The Commission has issued the enclosed Amendment No. 69 to Facility Operating License No. DPR-30 for Quad Cities Station Unit 2. This amendment is in response to your request dated July 27, 1981, as supplemented by letters dated August 21, 1981, and December 3, 1981.

This amendment (1) authorizes operation in Cycle 6 using 224 assemblies of prepressurized 8 x 8R fuel, including 144 bundles of GE barrier fuel, (2) incorporates revised Minimum Critical Power Ratio (MCPR) limits in response to plant specific analyses for Cycle 6, (3) incorporates new Maximum Average Planar Linear Heat Generation Rate (MAPLHGR) limits for the barrier fuel, (4) deletes MCPR, MAPLHGR and Linear Heat Generation Rate (LHGR) operating limits for all 7 x 7 fuel (none to remain in the core), and (5) changes the pressure safety limits due to the recently installed Anticipated Transients Without Scram Recirculation Pump Trip.

Amendment No. 69  
License No. DPR-30

SUPPORTING AMENDMENT NO. 69 TO FACILITY LICENSE NO. DPR-30

Figure 3.5-1  
(Sheet 1 of 5)

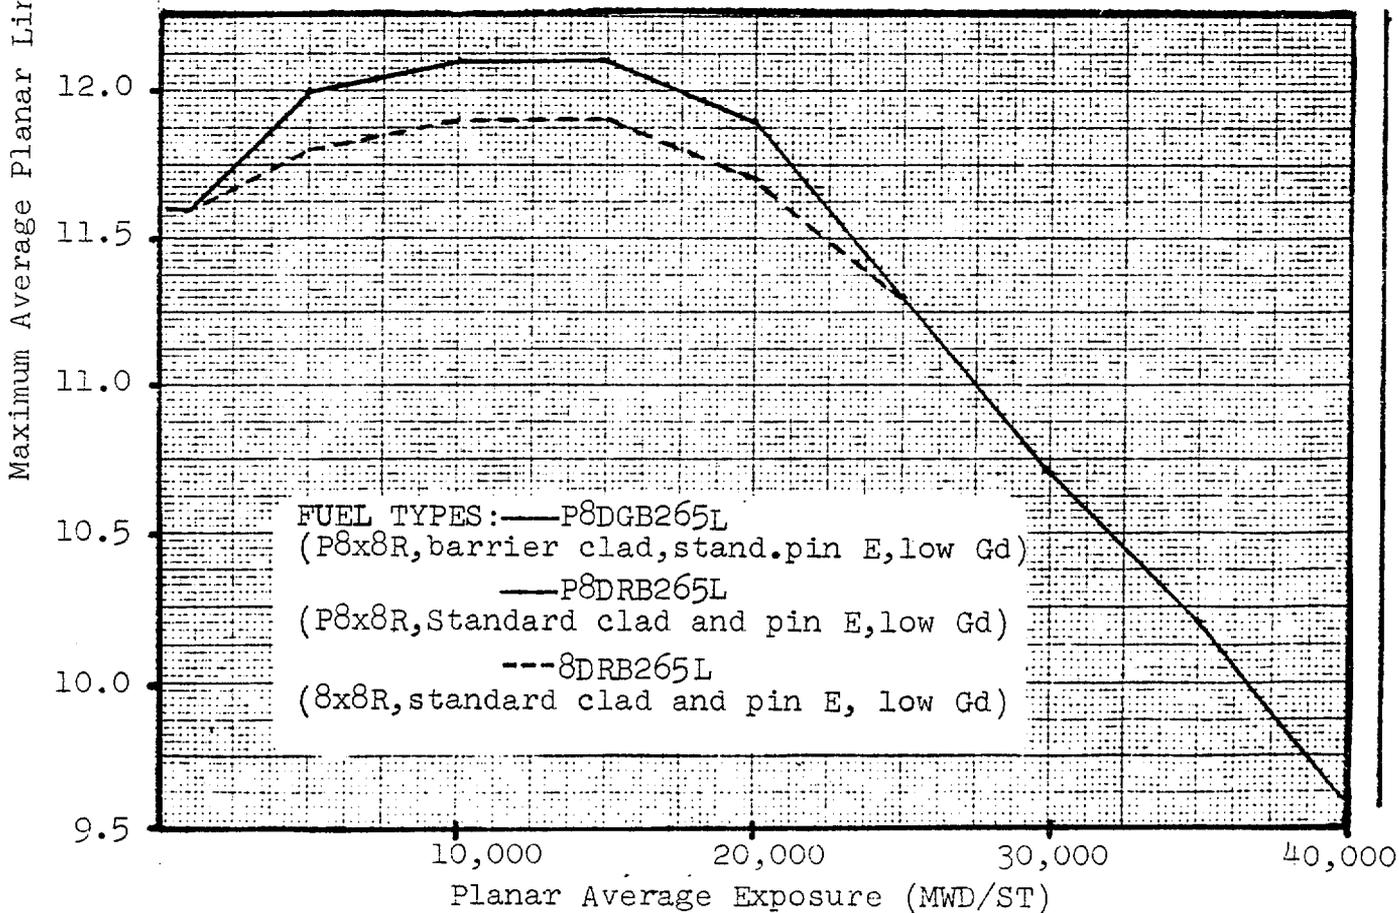
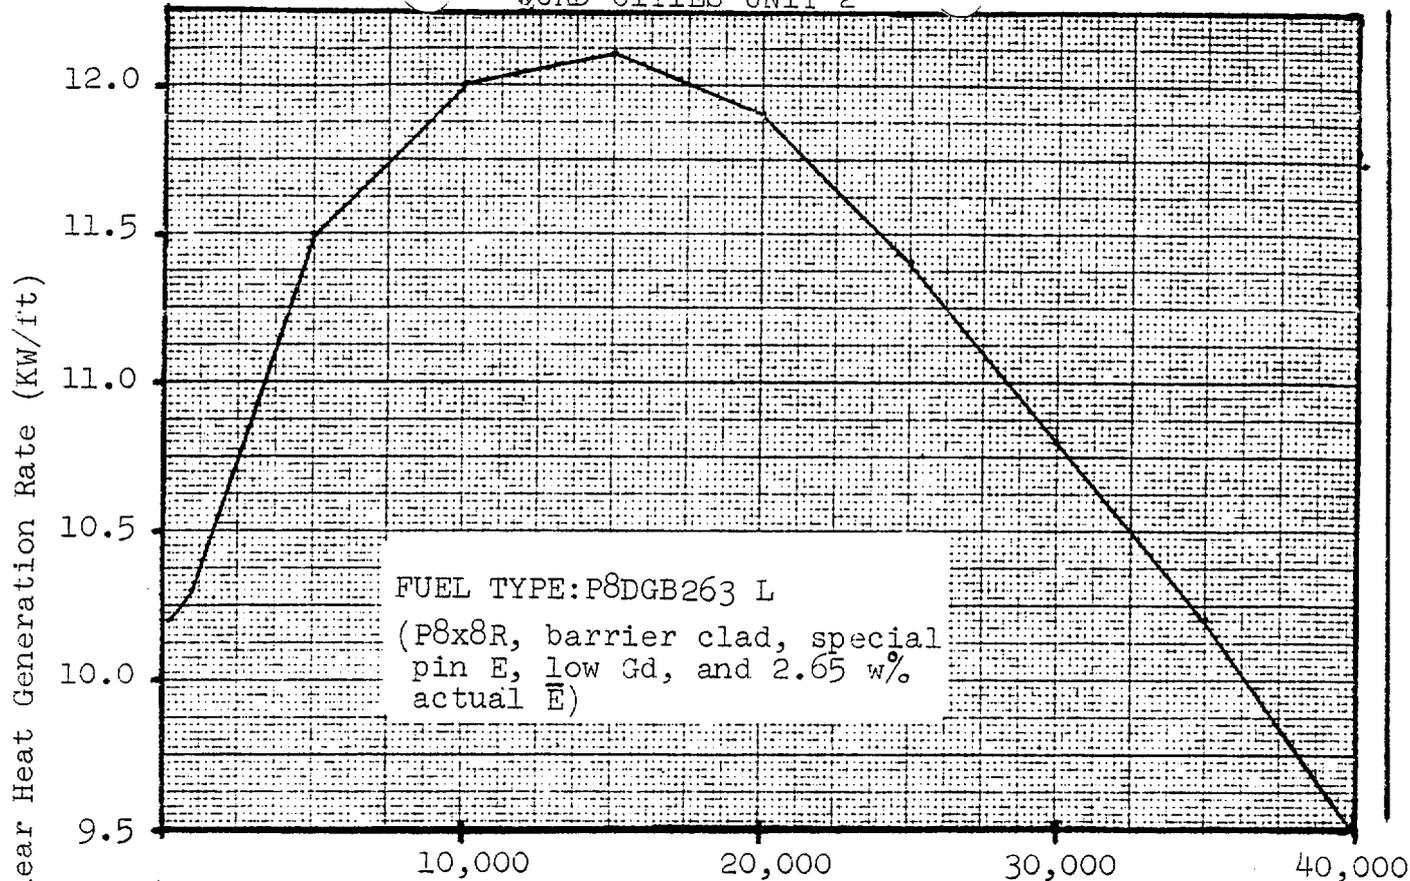
The previously approved reference document NEDO 24146A (see reference 12) contains an approved ECCS analysis for Quad Cities Unit 2, and continues to serve as the basis for generation of MAPLHGR limits for new fuel types. New MAPLHGR limits for the four barrier fuel types being loaded in the core for Cycle 6 are based on Addenda to reference 12 and were provided in the licensee's submittal (see reference 1). A non-barrier fuel type which is otherwise identical to one of the four barrier fuel types is also being loaded in the Cycle 6 core. The barrier fuel (of that type) MAPLHGR limits apply directly to the non-barrier fuel for the otherwise identical design.

MAPLHGR limits to non-prepressurized fuel have previously been conservatively applied to prepressurized fuel because of the unavailability of the slightly relaxed prepressurized MAPLHGR limits. The prepressurized MAPLHGR limits are now available and are included for Cycle 6.
